Rule 34 Registration Mad Cow & Containments Section 12, T24S, R30E, Eddy County

Volume 2 In-Ground Containment Modification

RE: Vaughan Operating, LLC, Mad Cow Recycling Facility & Containments Permit Number 2RF-207, Facility ID fVV2426951124, Rule 34 Produced Water Containments, Section 12 T24S R30E, Eddy County

SHEET:
5 of 13
CG- 100

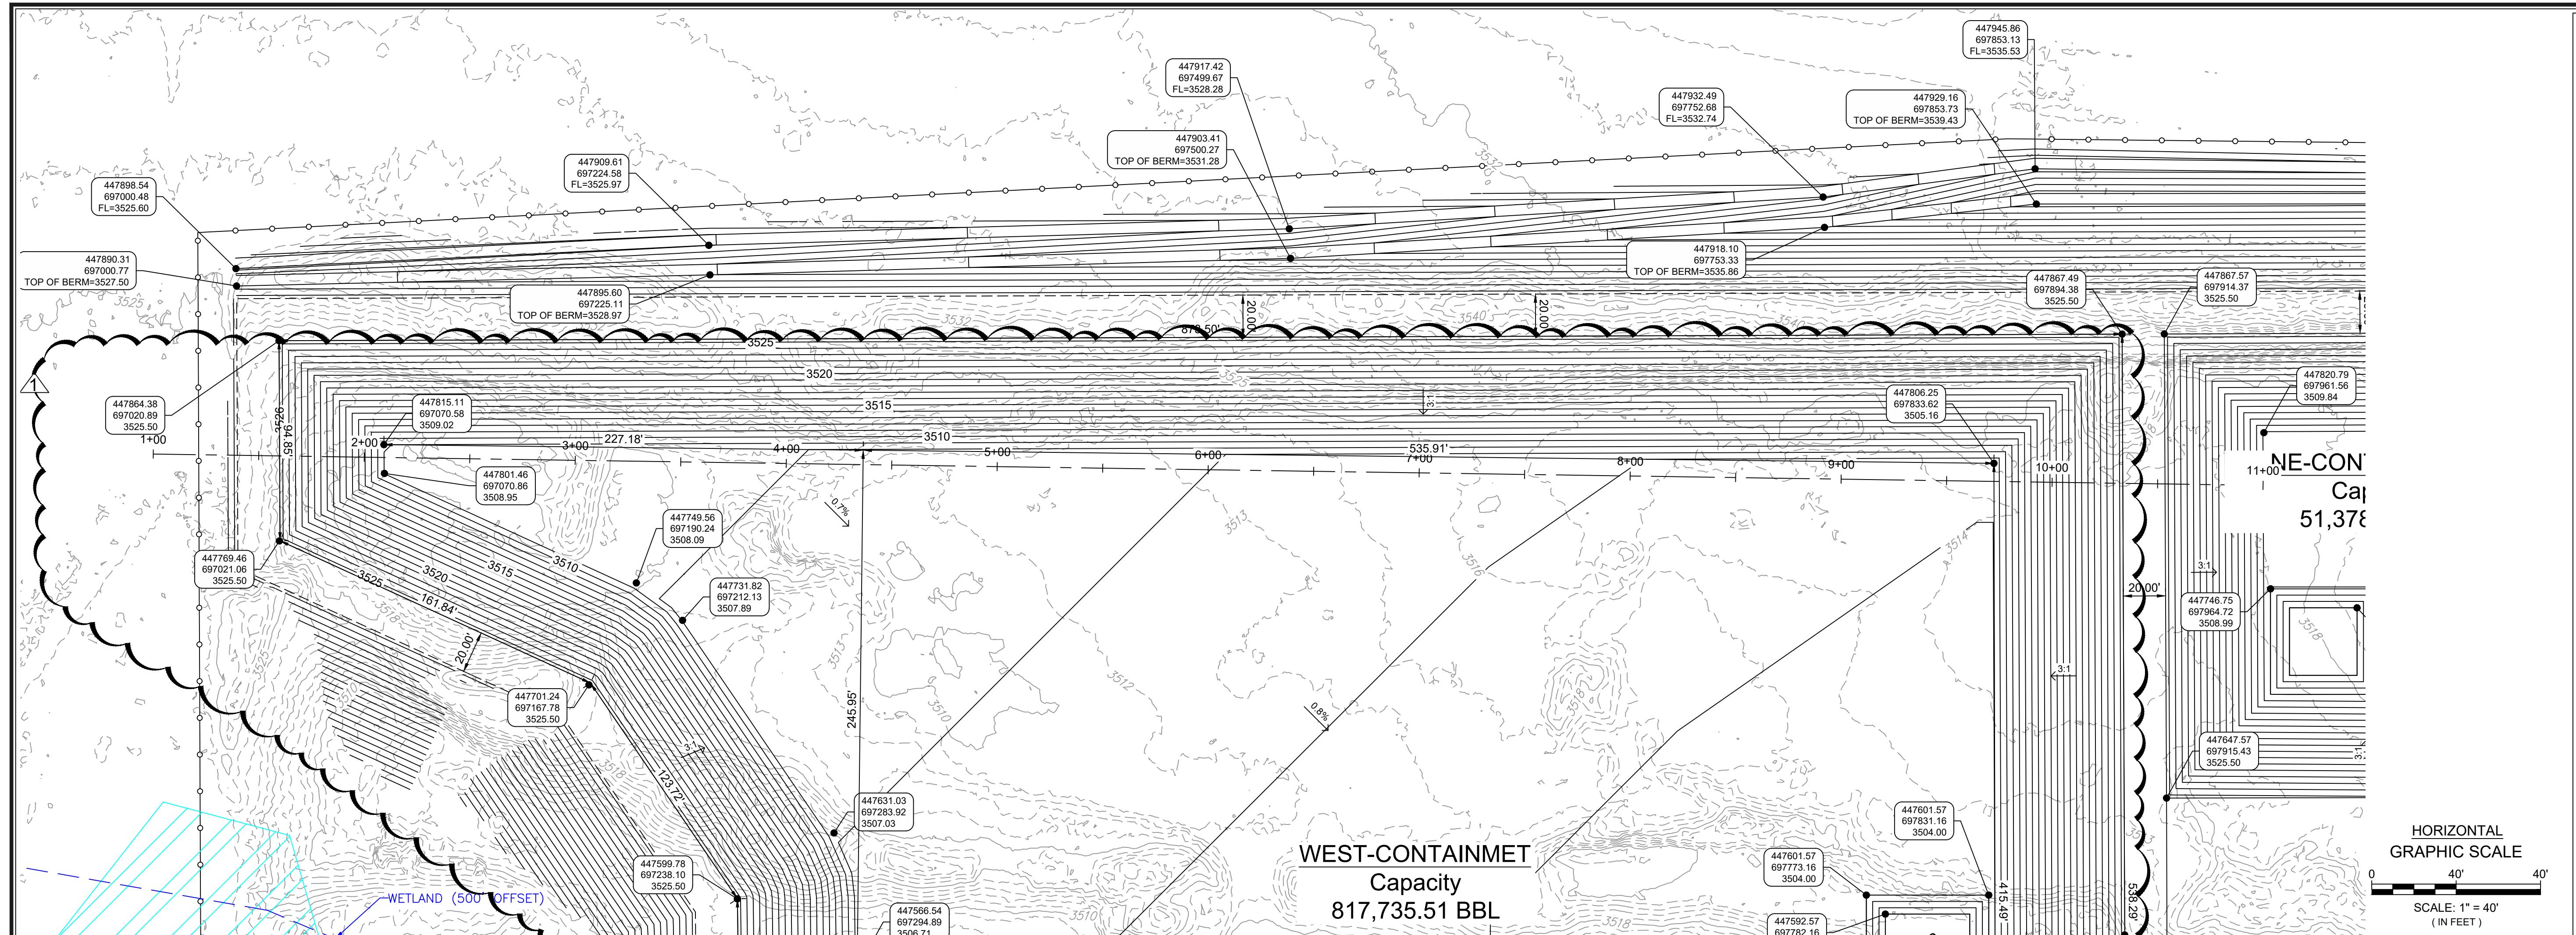
No.	DATE	DESCRIPTION
10/10/24		WEST PONDS COMBINED

TYPE OF SURVEY:
WEST-CONTAINMENT
WEST - EAST
PLAN AND PROFILE
OF
PROJECT NAME:
MAD COW
CONTAINMENT
FOR
CLIENT:
LON LON RANCH LLC
PROJECT NUMBER:
23156
PROJECT ENGINEER:
JEREMY BAKER, PE
DRAWN BY:
LPS

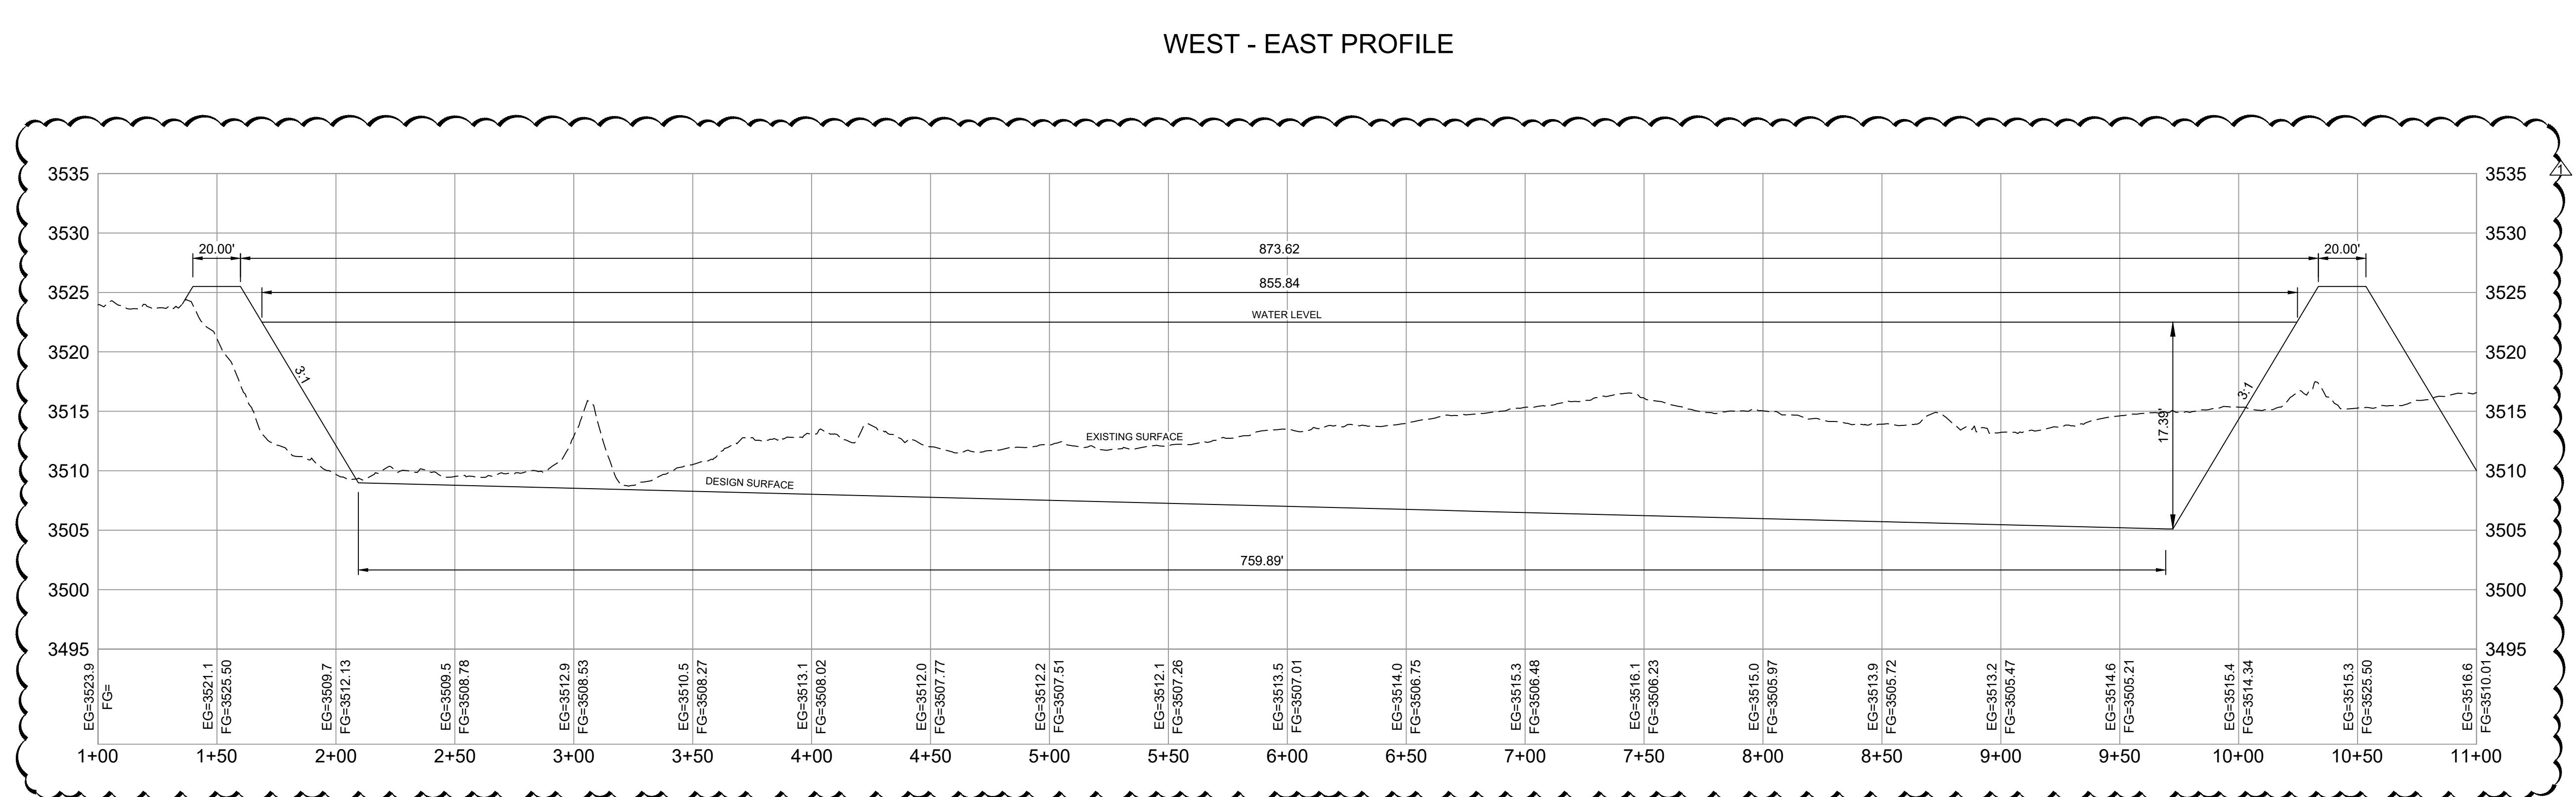
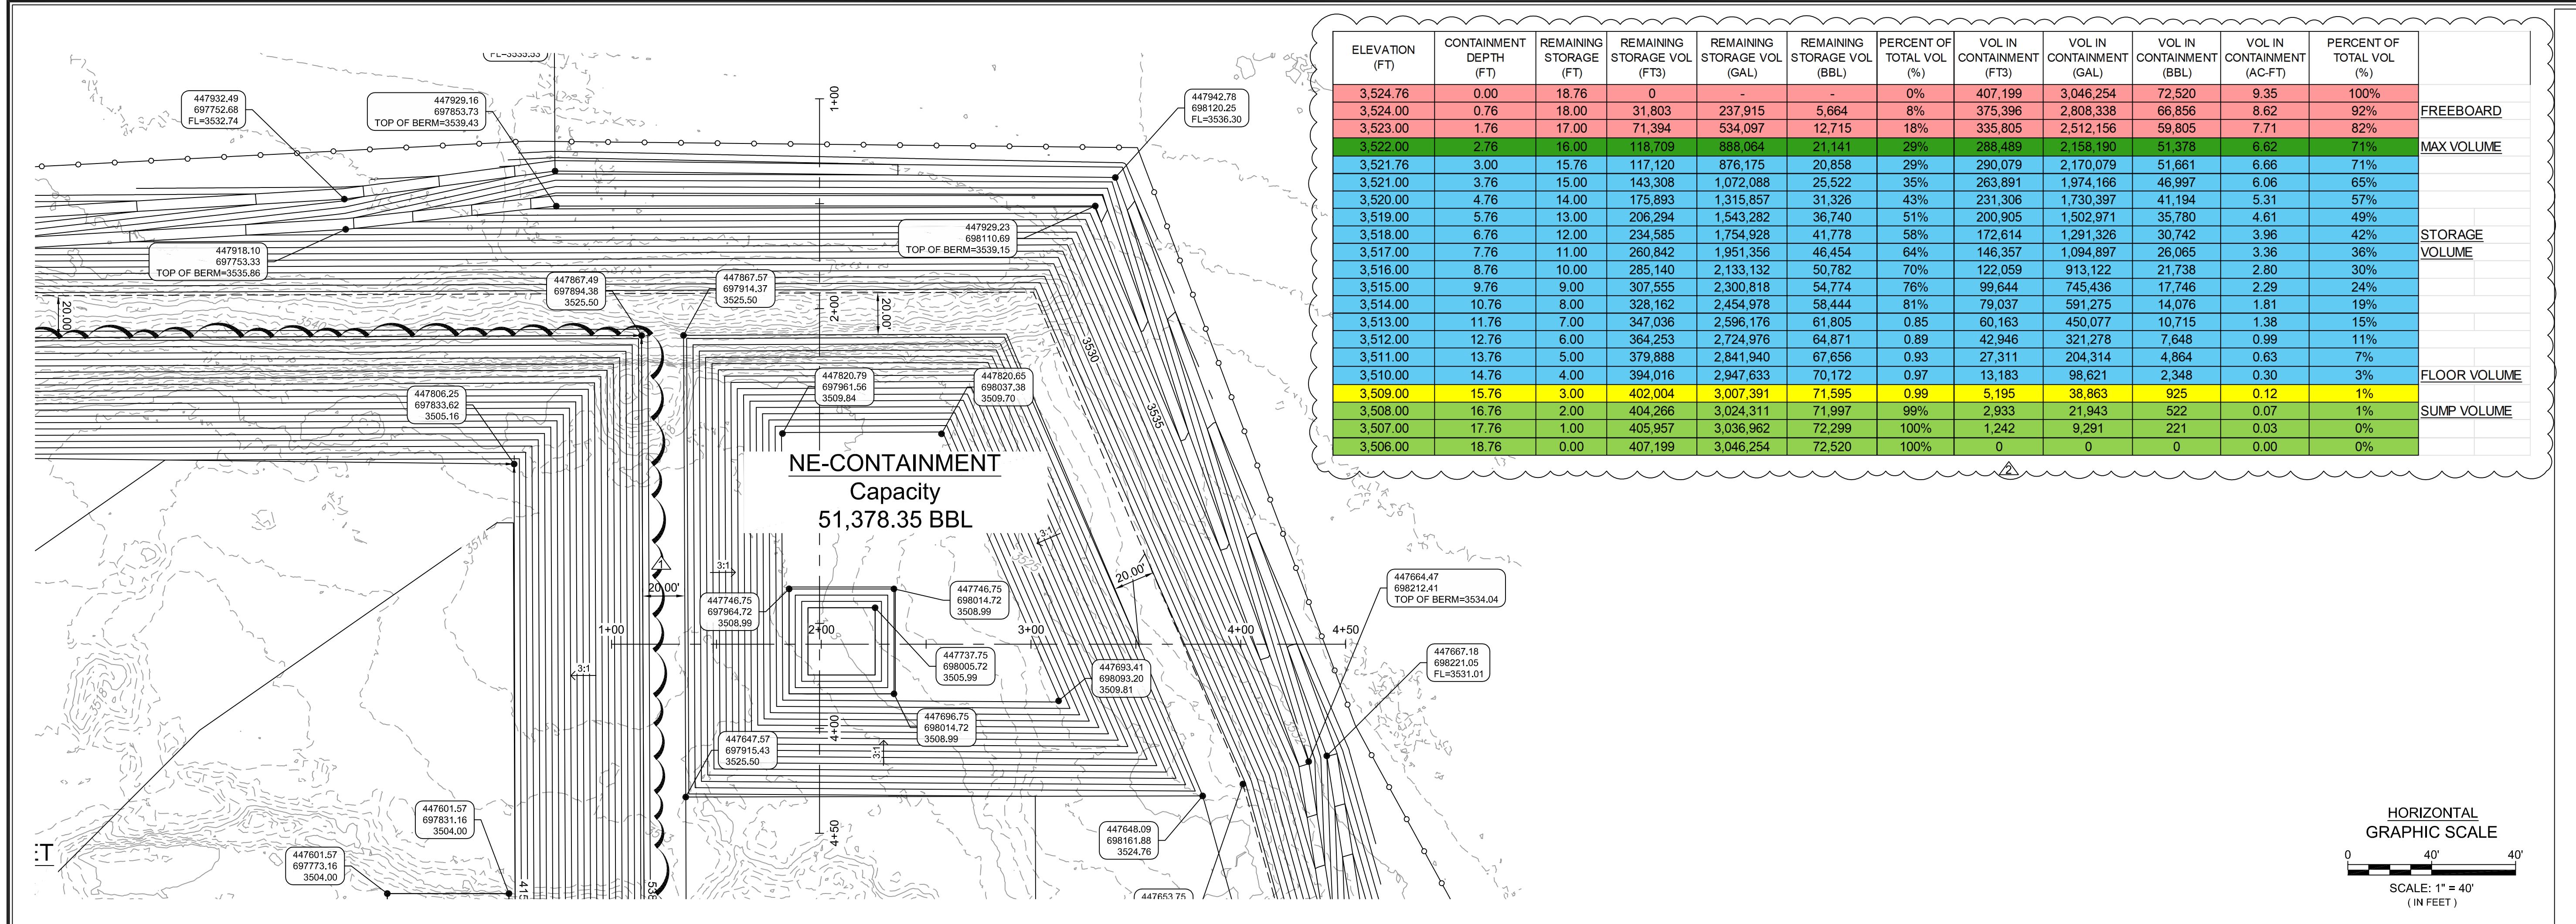
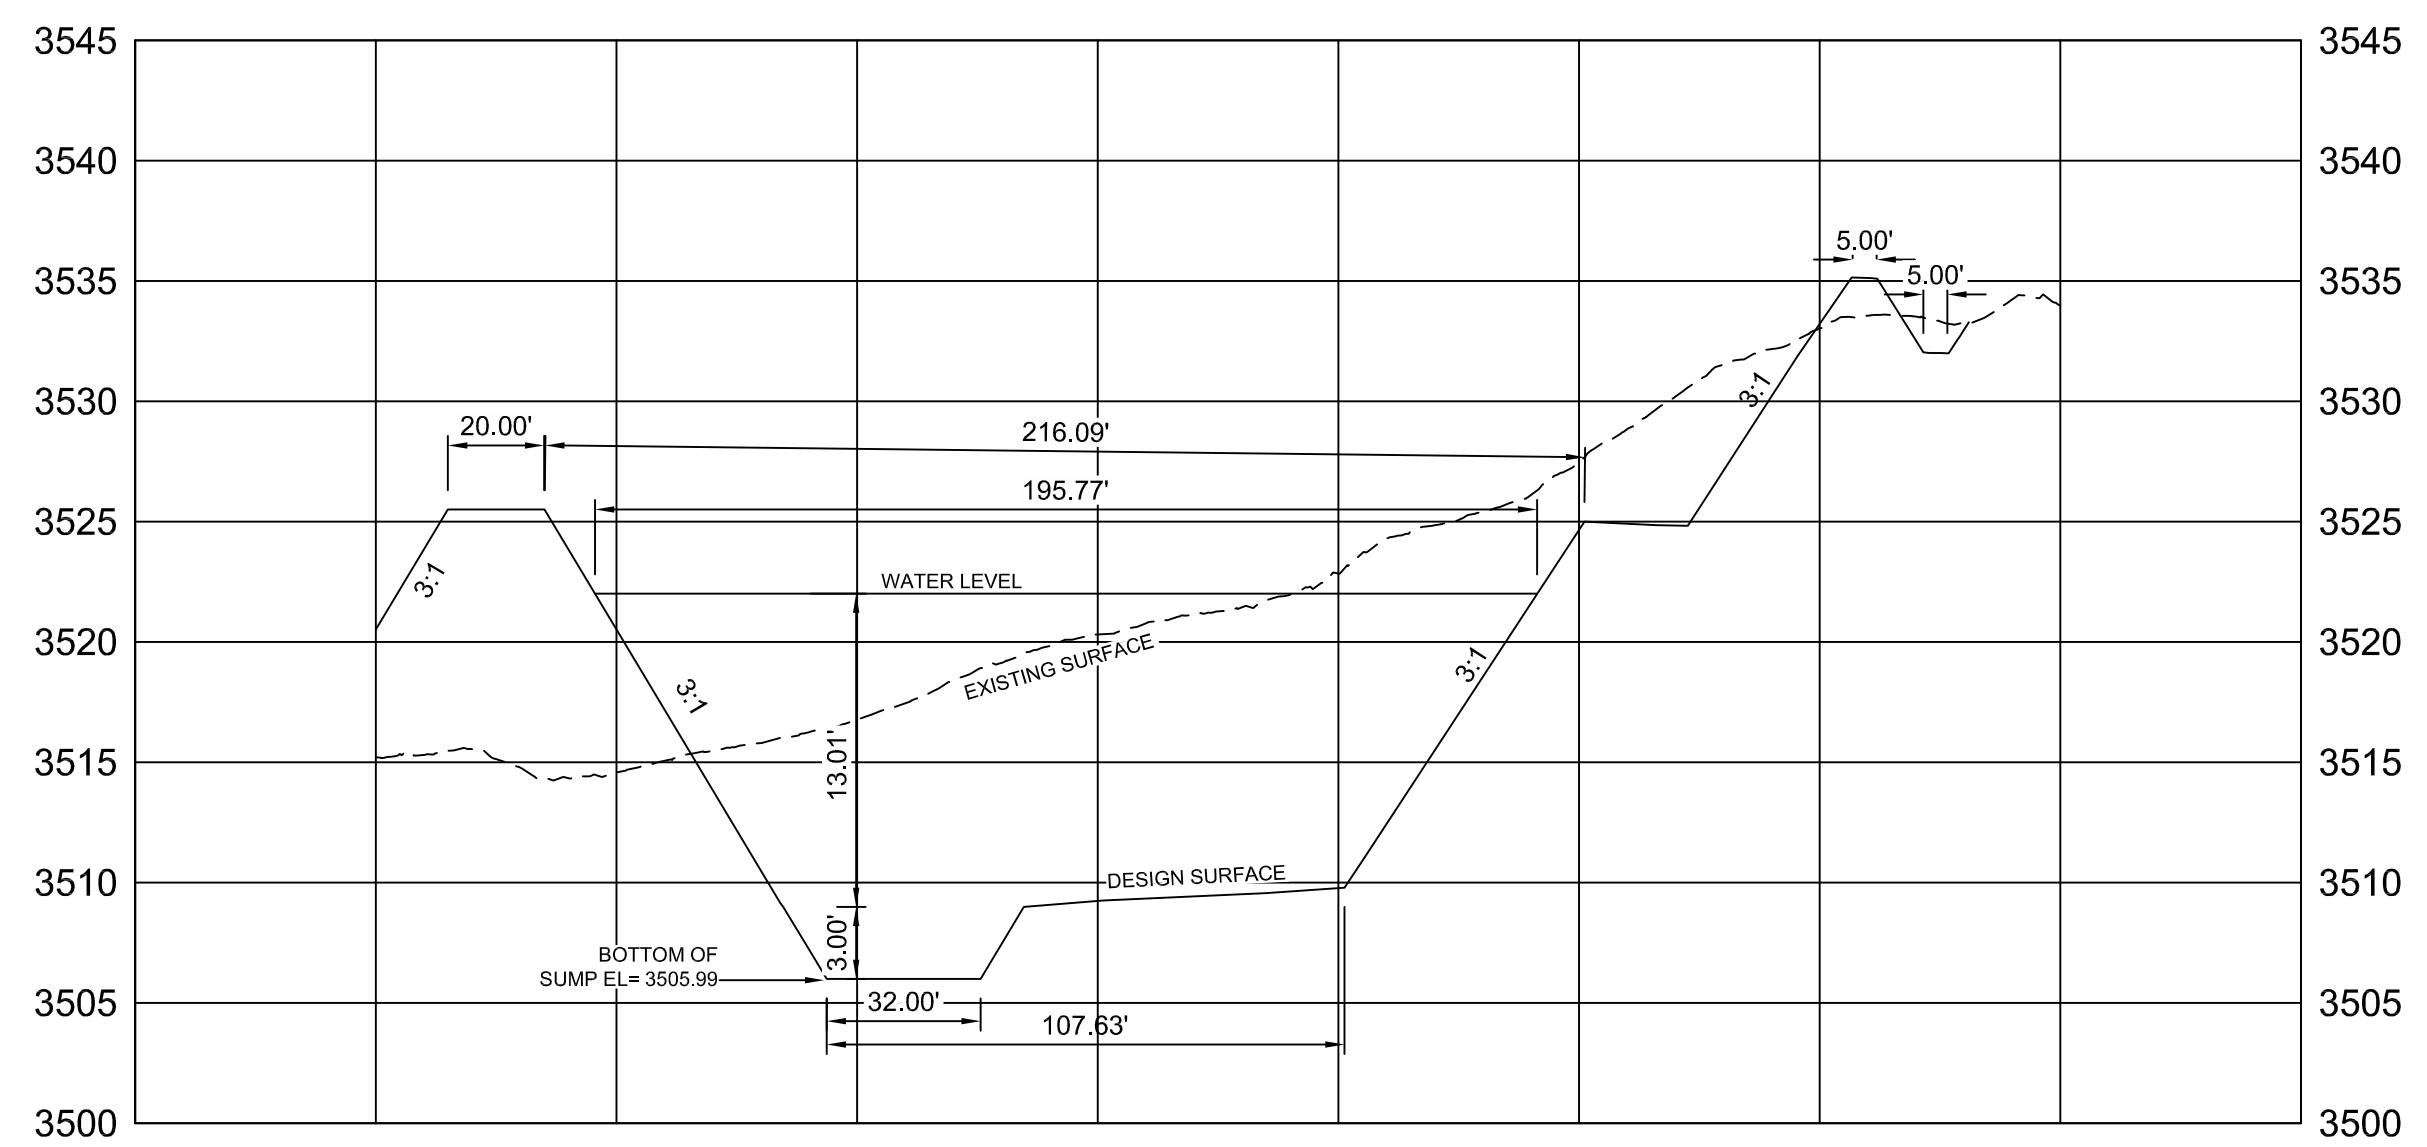
REVISIONS
No. DATE DESCRIPTION
10/10/24 WEST PONDS COMBINED
